RE: **P.Z. 13-2012 U Gas, Inc. (17551 & 17555 Chesterfield Airport Road)**: A request for an amendment to City of Chesterfield Ordinance 2379 for modifications to permitted uses and development standards for a 2.31 acre tract of land located on Chesterfield Airport Road, approximately 100 feet east of Long Road (17U140263, 17U140203).

Planning Commission Vote Report

Petition: **P.Z. 13-2012 U Gas (17551 & 17555 Chesterfield Airport Road)**

U-GAS CHESTERFIELD PRELIMINARY DEVELOPMENT PLAN

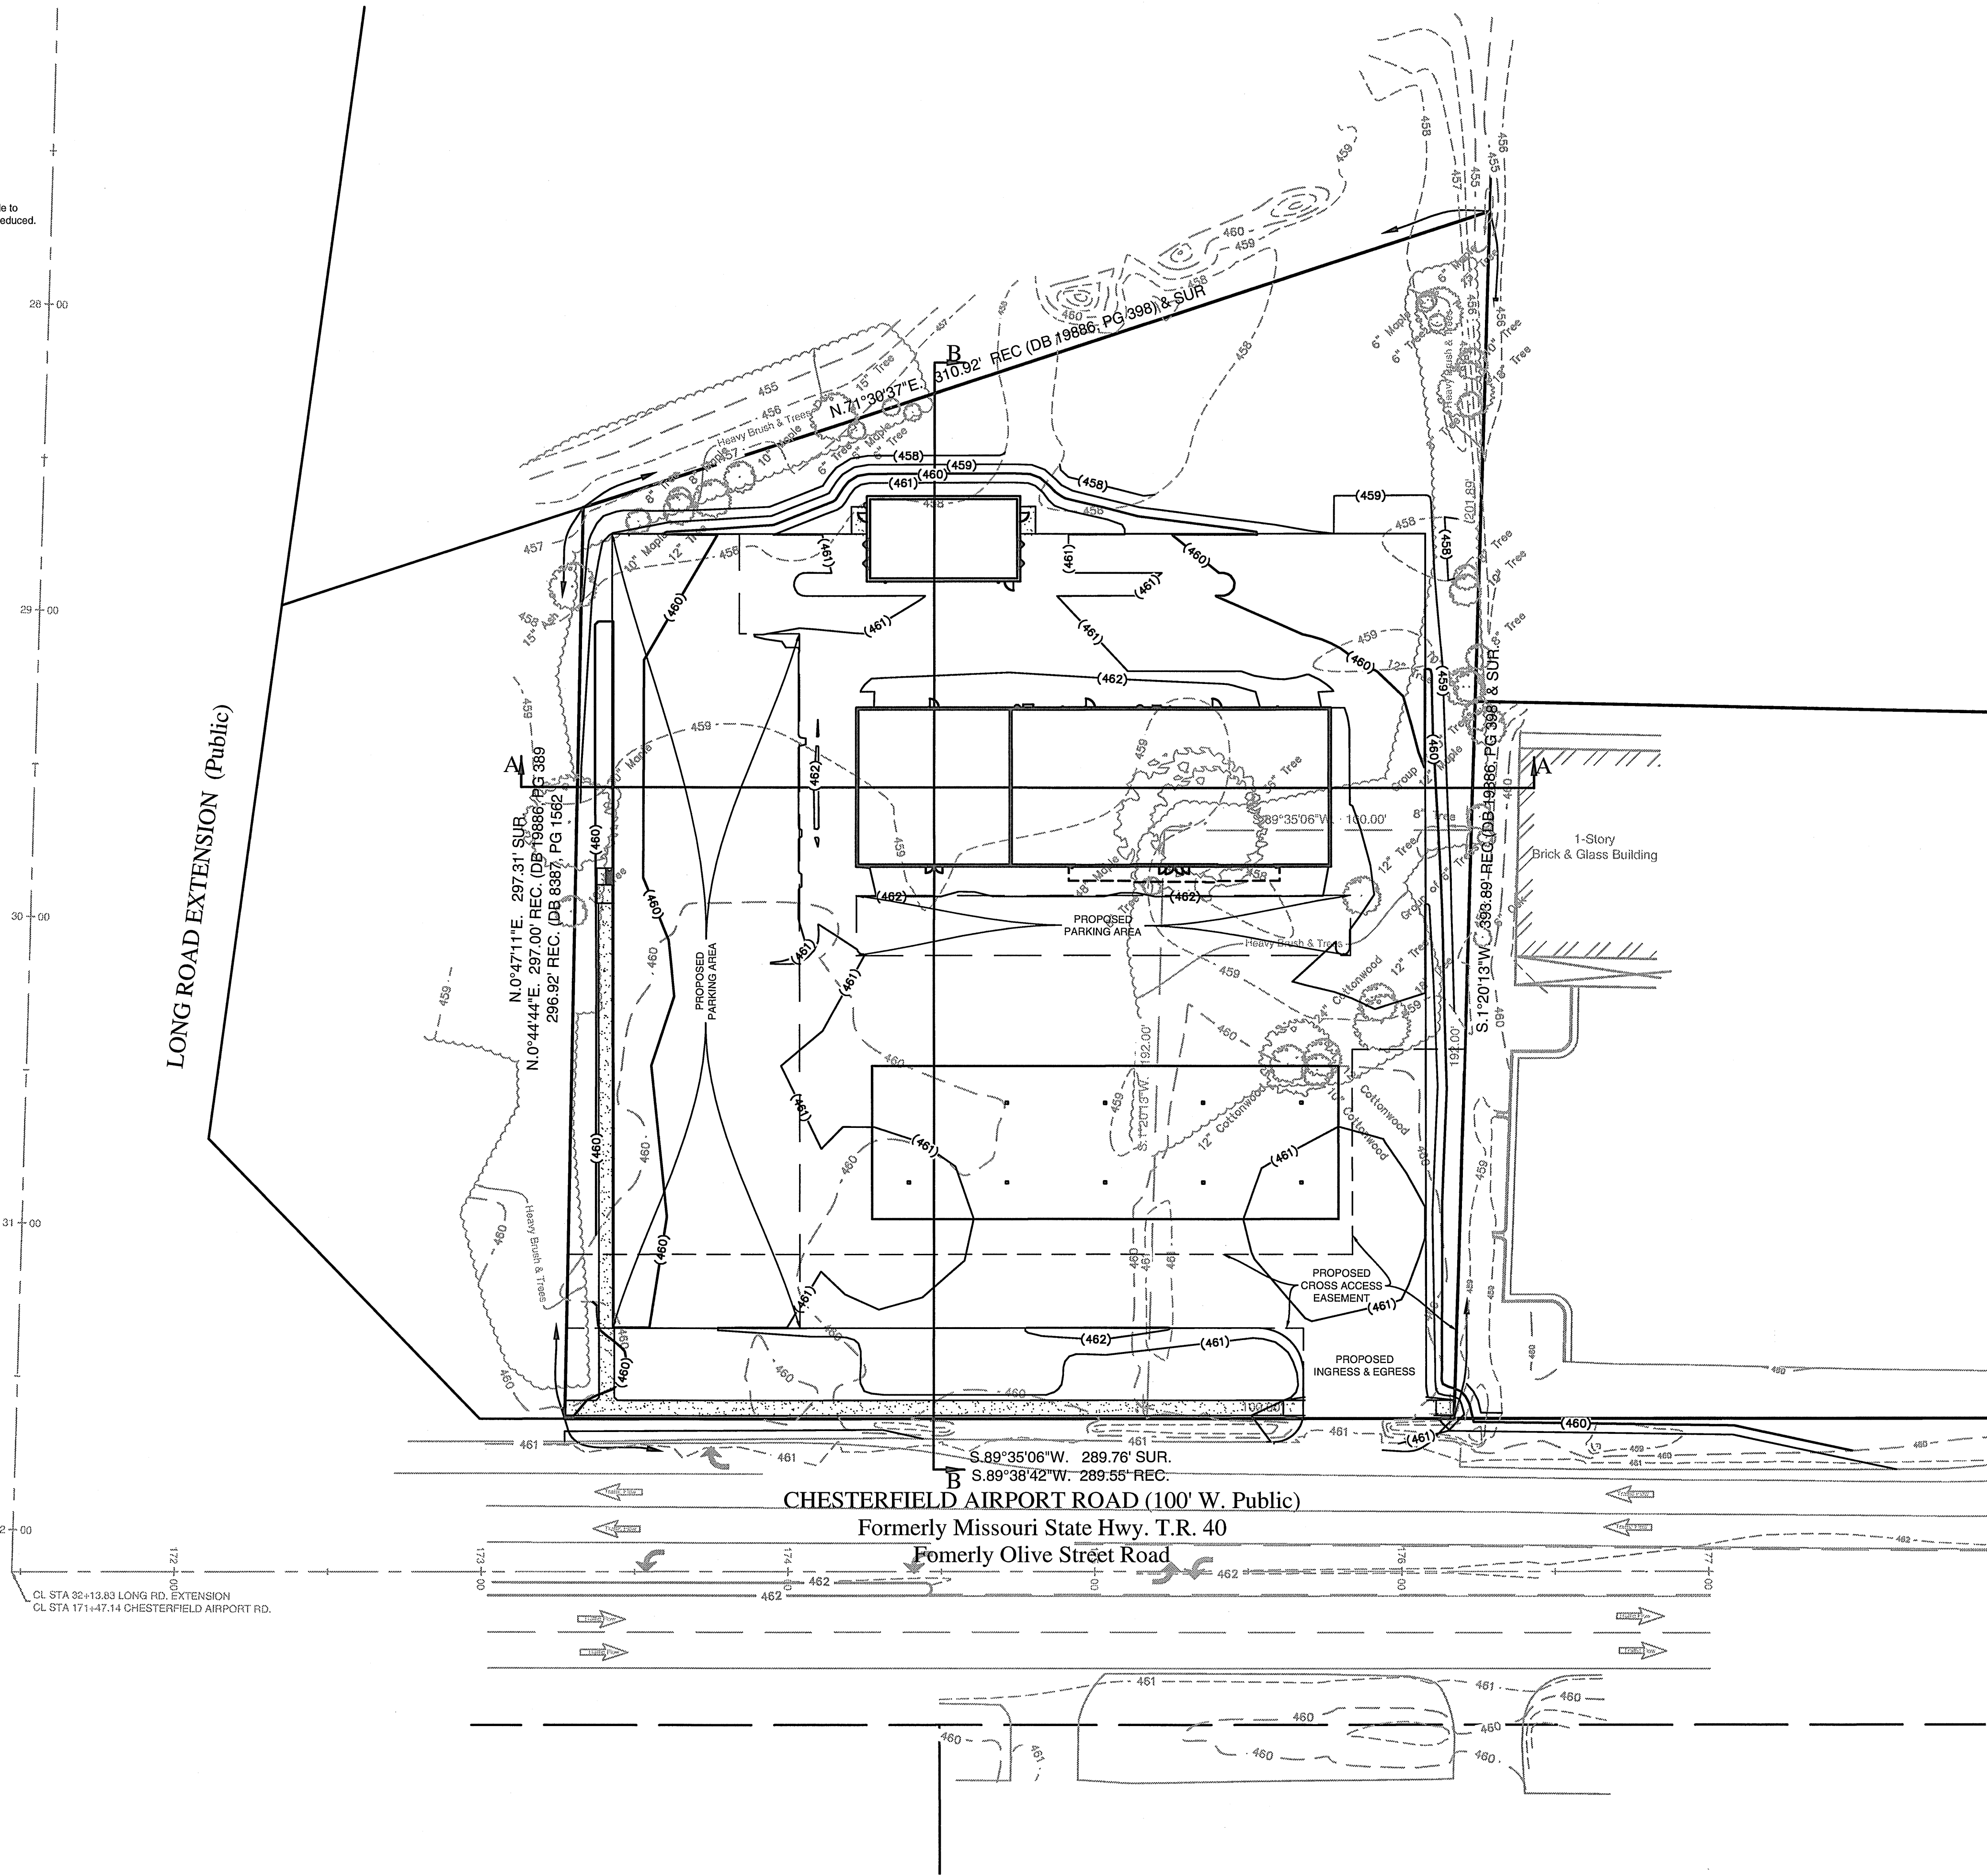
1. Remove the following items from the Preliminary Plan:
 - a. Trash enclosure;
 - b. Gas pumps and canopy;
 - c. Parking curbs;
 - d. Building/use labels.

2. Add the following items to the Preliminary Plan:
 - a. Key plan;
 - b. Cross access to adjacent parcels to the east and west.
3. The building height as requested in the project narrative is listed as two (2) stories or 40 feet. The current building height requirement in Ordinance 2379 is 42 feet. Please clarify that the petitioner is requesting more restrictive building height requirements than currently required by Ordinance 2379.

1. The trash enclosure, gas pumps, canopy, parking curbs and building labels have been removed from the Preliminary Plan.
2. The key map and cross access easement to the east and west have been added to the Preliminary Plan.
3. We request the 42' building height be retained.
4. We request the current maximum building footprint of 32% be retained.
5. It is the intent of the petitioner that only one drive thru use and the car wash would be operating on the site at any given time. A stipulation in the ordinance to that effect is acceptable to the petitioner.
6. The Tree Stand Delineation has been submitted for your review.
